STATE OF CONNECTICUT
CONNECTICUT SITING COUNCIL

RE: **PETITION NO. 1426** - DG Connecticut Solar III, LLC declaratory ruling, pursuant to Connecticut General Statutes §4-176 and §16-50k, for the proposed construction, maintenance and operation of a 4.9-megawatt AC solar photovoltaic electric generating facility located west of the Ellington town boundary at 341 East Road, East Windsor, Connecticut and associated electrical interconnection. **Development & Management Plan Revision.**

Re: PETITION NO. 1426 – DG Connecticut Solar, III, LLC petition for a declaratory ruling, pursuant to Connecticut General Statutes §4-176 and §16-50k, for the proposed construction, maintenance and operation of a 4.9-megawatt AC solar photovoltaic electric generating facility located west of the Ellington town boundary at 341 East Road, East Windsor, Connecticut and associated electrical interconnection.

Subject: Solar One East Windsor – Sound control - Acoustical engineering design study

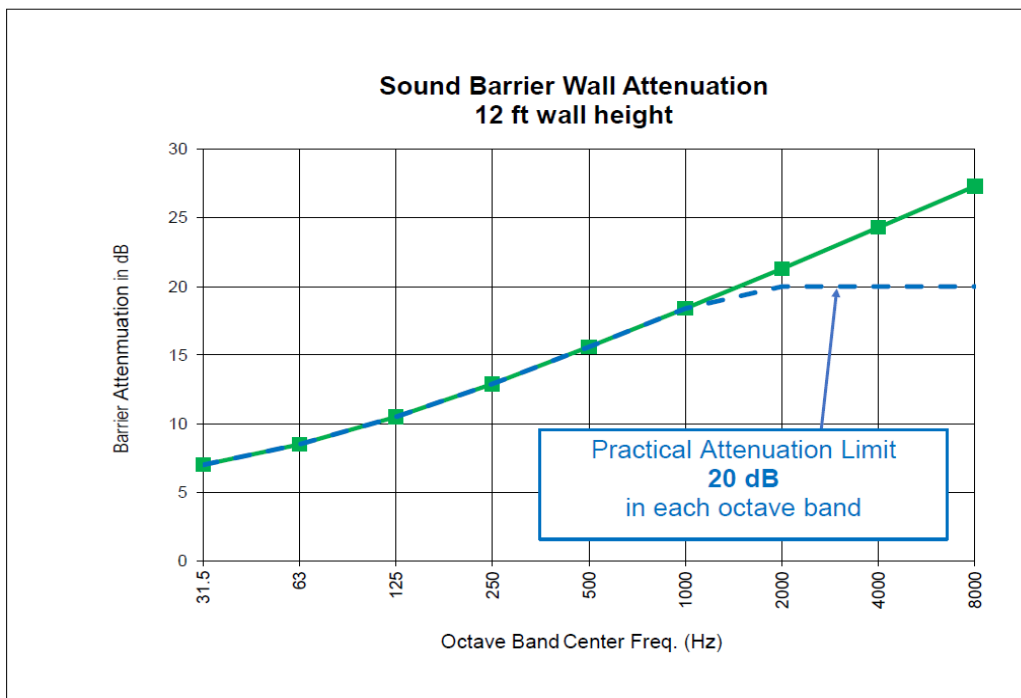
The sound control design features a sound barrier block wall, 12 feet high and located 5 feet to the north of the power inverter banks, between those power inverter banks and the nearby residences. The barrier wall shall be sized appropriately to comfortably intervene between the inverter bank at the facility and the neighbor residences to the north, allowing room for routine maintenance and for cooling air to circulate. A conceptual sketch of the wall in position to the north of the solar power inverter banks is shown below.

The sound barrier wall shall be constructed of 16 inch cinder blocks, of standard dimensions (16x8x8 inch), which have a weight of at least 28 pounds per piece. The wall shall be laid in courses 16 inches thick. This yields a face weight for the wall of about 63 pounds per square foot.

The barrier wall design shall be compatible with structural engineering best practices for sustaining wind loads, and frost heaves for the existing soil conditions. The wall shall be set on proper footings prepared in accordance with the State of CT Building code. Vertical and horizontal steel reinforcement bars shall be placed in accordance with the State of CT Building Code and best practices. Support buttresses shall extend northward from the wall at regular intervals. The sound barrier wall and buttresses shall be grouted or filled with sand as needed to support the reinforcement bars, per best practices, and shall be capped with weather resistant capstone blocks.

The barrier wall and buttresses shall be sealed with a weatherproof latex and acrylic paint to prolong the life of the block elements.

No holes, penetrations or gaps shall be allowed in the sound barrier wall which allow sound to escape through the wall to the north side of the wall. Gravel shall be installed in the footing trench around the barrier wall to allow for drainage, per structural engineering best practices.

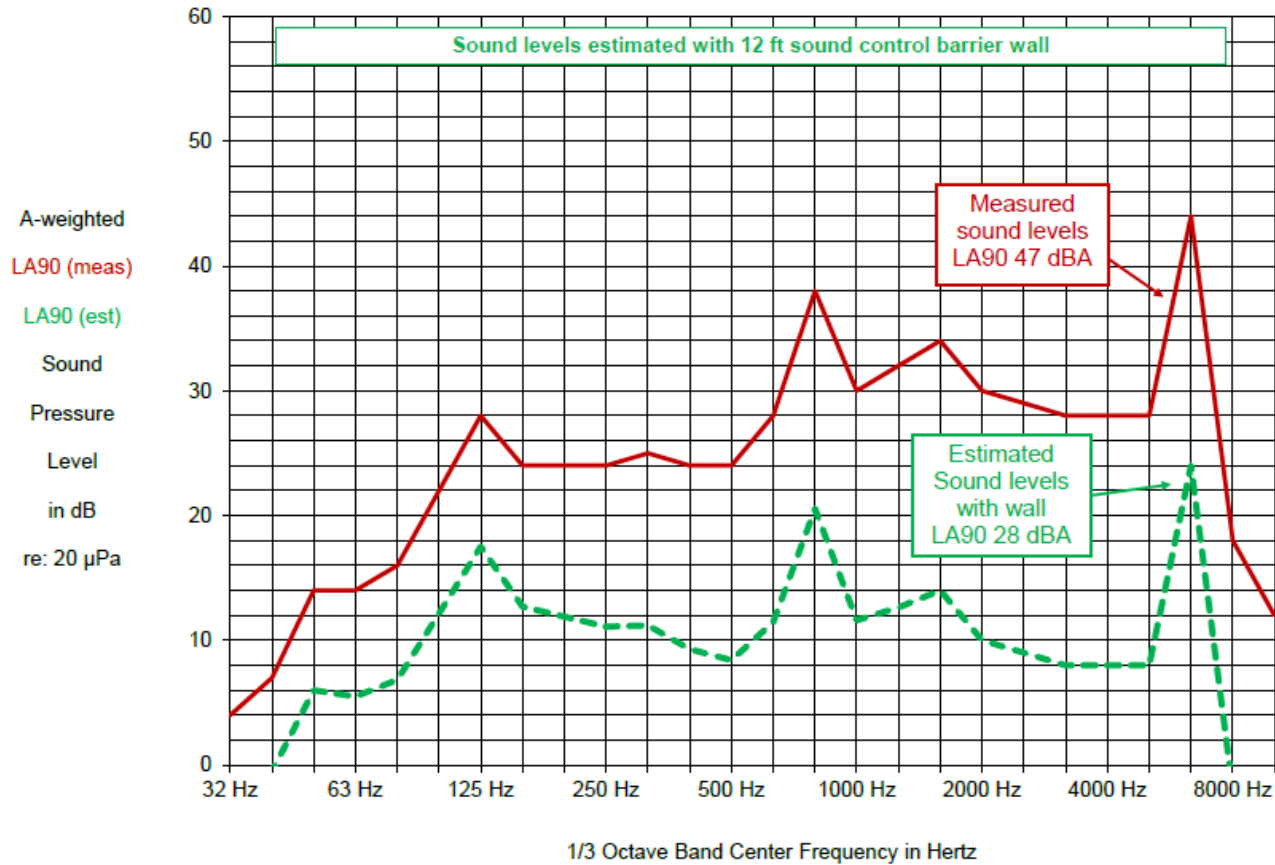
It was determined that a 12 foot wall would provide the best sound attenuation for a realistic wall. A graph which shows the calculated sound attenuation for the 12 foot high wall is shown below. Note that the practical limit for sound attenuation provided by a wall that is open to the sky is 20 dB in each octave band.

As seen in the barrier acoustical calculations (above), the amount of sound reduction provided by the sound barrier wall increases with increasing frequency, until it reaches a practical maximum of about 20 dB in the higher frequency bands.

The calculated practical limit sound attenuation values for the 12 foot wall were applied to the measured sound spectrum at the nearest residential property line to the solar power inverters.
